FAIRFAX COUNTY

Re: Interpretation for RZ 1998-SU-057, Timber Ridge, Tax Map 56-2 ((1)) 6: Relocated Tot Lot

Re: RZ 1998-SU-057
Interpretation Request – Ridgetop Tot Lot

Supplemental Exhibit for Interpretation Request

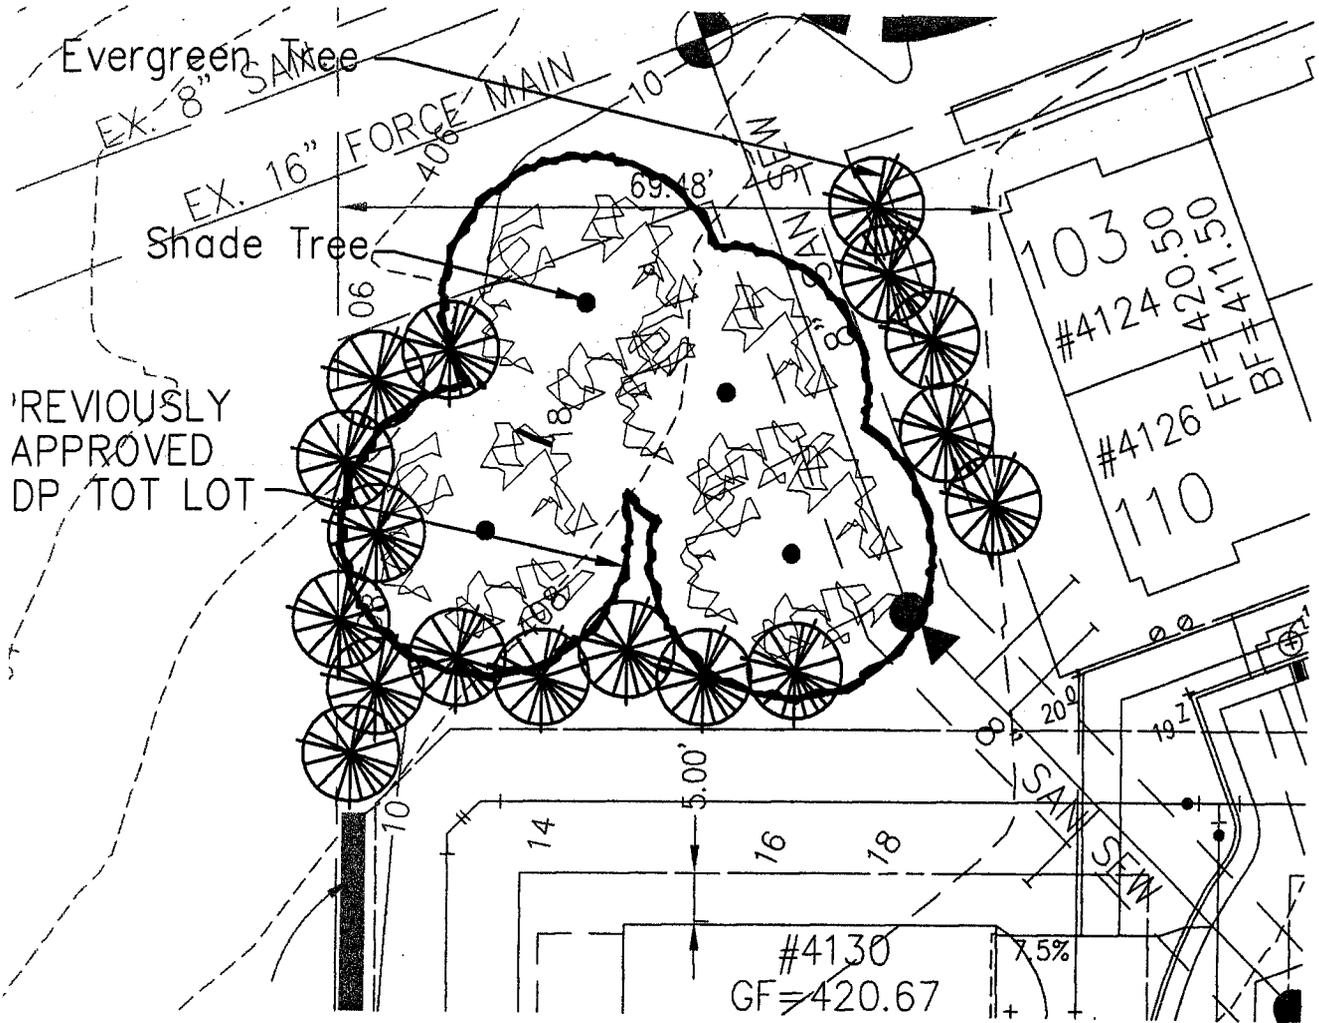
We have looked into the questions that you had regarding the size of the previously approved tot lot vs. the proposed tot lot. Both are the same size .08 acres. I have made a chart to evaluate the plant counts according to 10-year tree canopy coverage for each of the areas in question. Please see below.

8	Shade Trees	250 ea. 10 yr. Cover	= 2,000
103	Shrubs	0 ea. 10 yr. Cover	= <u>0</u>
			Total = 2,000

4	Shade Trees	250 ea. 10 yr. Cover	= 1,000
17	Evergreens	100 ea. 10 yr. Cover	= <u>1,700</u>
			Total = 2,700

The proposed tot lot and the open space cover

Combined Total = 4,700

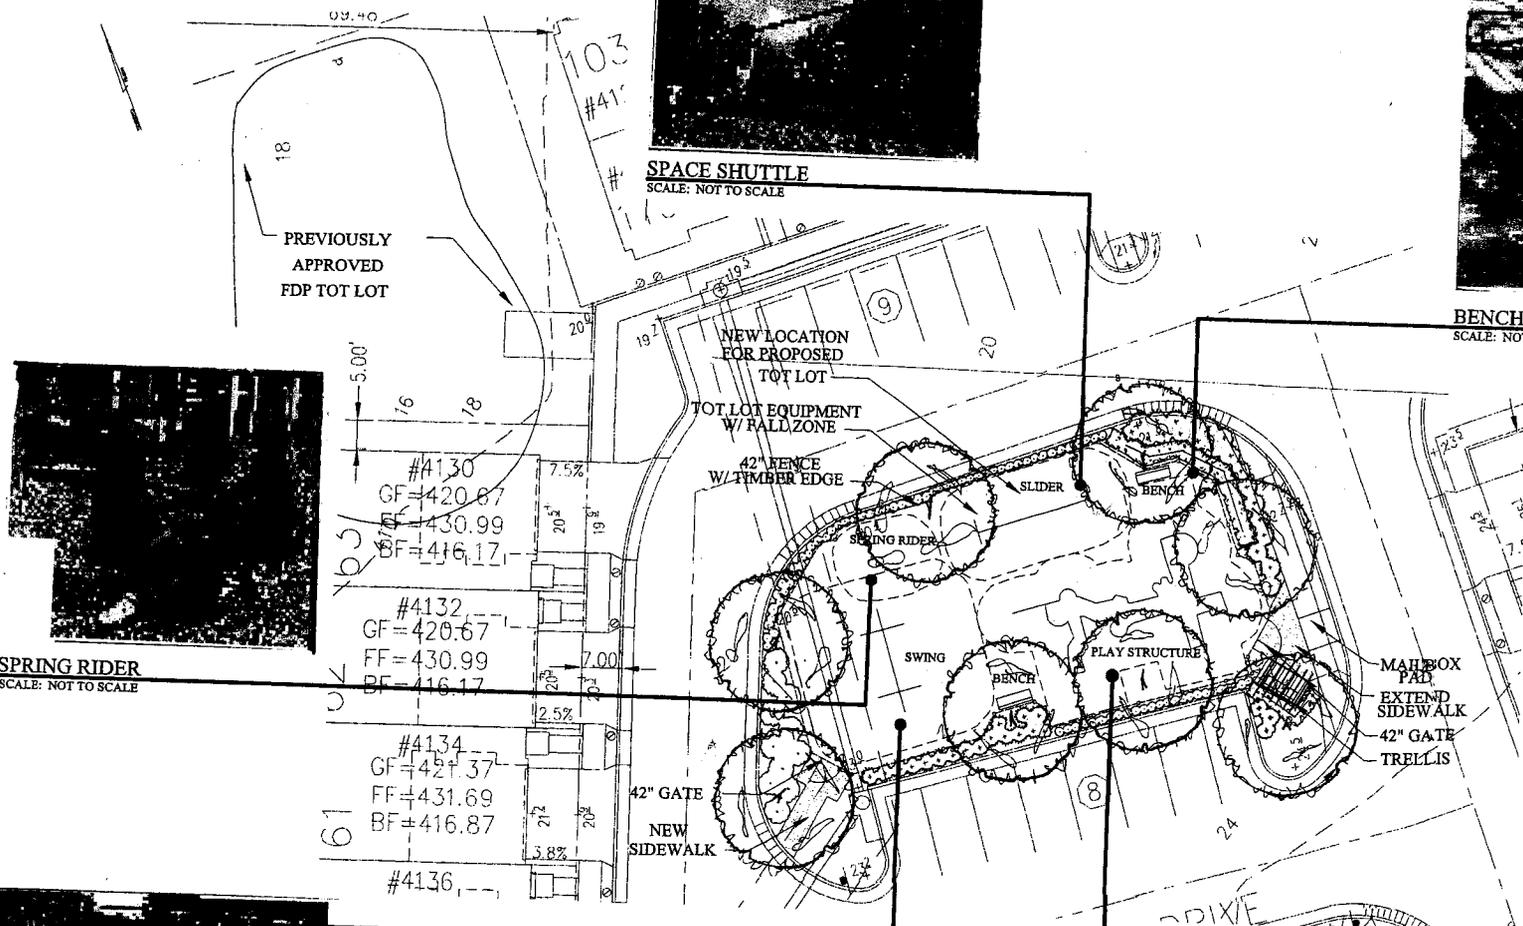
Your current proposal to locate the tot lot in the parking area will provide a level area and will consist of approximately 3,500 square feet. All the playground equipment shown on the CDP/FDP, including the swing set, will be provided. The central location of the proposed tot lot will allow more residents immediate access. The attached supplemental exhibit shows that

landscaping (projected 10-year tree canopy coverage) will be provided with the proposed tot lot design as shown on the CDP/FDP.

Please see the enclosed Supplemental Exhibit for Interpretation Request. We are providing the equivalent amount of tree canopy coverage that was previously approved in the FDP plan. We are providing a total of 29 trees for the tot lot and previously approved tot lot areas combined. The tot lot design on the proposed plan provides shrubs in tot lot area. We realize that the shrubs do not count towards the canopy calculation but are certainly beneficial in enhancing the tot lot area.

It is my determination that the proposed relocation of the tot lot is in substantial conformance with the proffers and the CDP/FDP. This determination has been made in my capacity as the duly authorized agent of the Zoning Administrator.
